COQUILLE INDIAN TRIBE

KILKICH TRANSPORTATION SAFETY PROJECT Response to New Intersection Questions & Concerns September 20, 2023

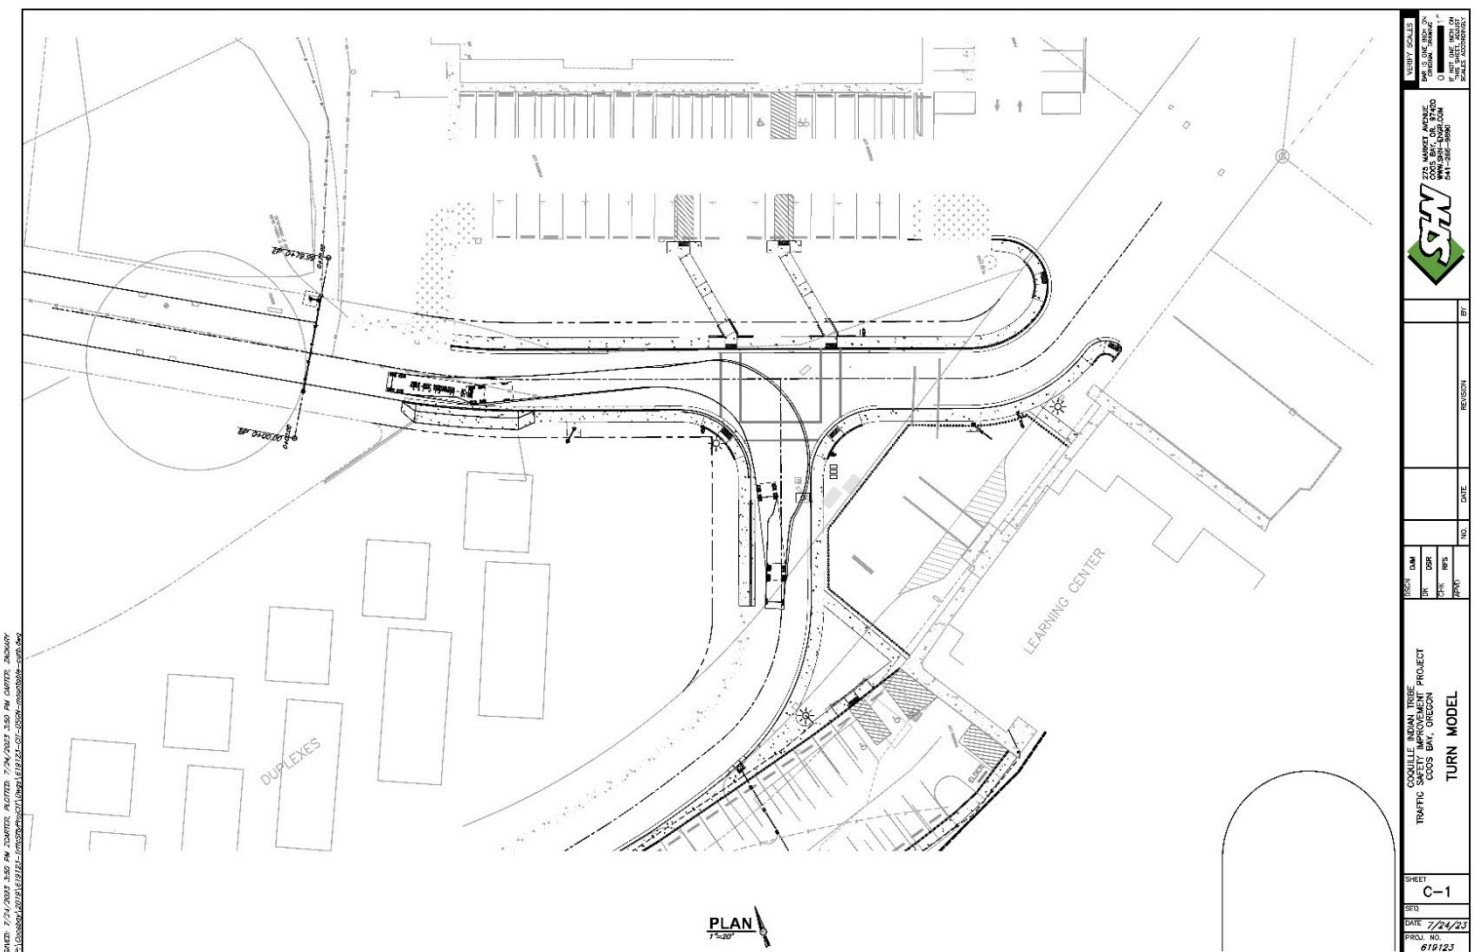
Why is the new intersection so narrow? It seems narrower than standard residential streets, narrower than it was before, and narrower than other spots on Kilkich.

The radius of the north curb when turning north (left) from Miluk Drive onto Mexeye or turning west (right) from Mexeye Loop onto Miluk Drive is too tight. Large vehicles must turn into the oncoming traffic lane and/or go up on the curb.

- It does feel narrow with the construction cones and laborers still working in the road.
- Also, the final asphalt for the top of the road hasn't been laid yet, and there are 12 inches on each side of Miluk Drive, at the new intersection, that are raised (the curb/gutter lip), that will be flush and part of the drivable road surface once the project is complete.
- When finished Miluk Drive will be 26 ft wide (see diagram below).

- This is slightly wider than the original width of Miluk Drive (25.5 ft) at the intersection.

- CIT staff have physically measured the radii of both the north and south curbs at the new T-intersection and confirmed that they were correct at 30' and that overall, the construction was happening per the approved design and construction documents (see timeline above).
- SHN Engineering completed a turn model confirming that trucks up to DW-50 (defined as having two units with a width of 8.5 feet and with the wheelbases of the two units (to the rear axle) 20 and 30 feet, for a total of 50 feet from the front wheels to the rear wheels, with a front overhang of 3 feet) could make the turn, although some may have to turn into the oncoming traffic lane to do so. (See Miluk Right and Mexeye Right diagrams below).
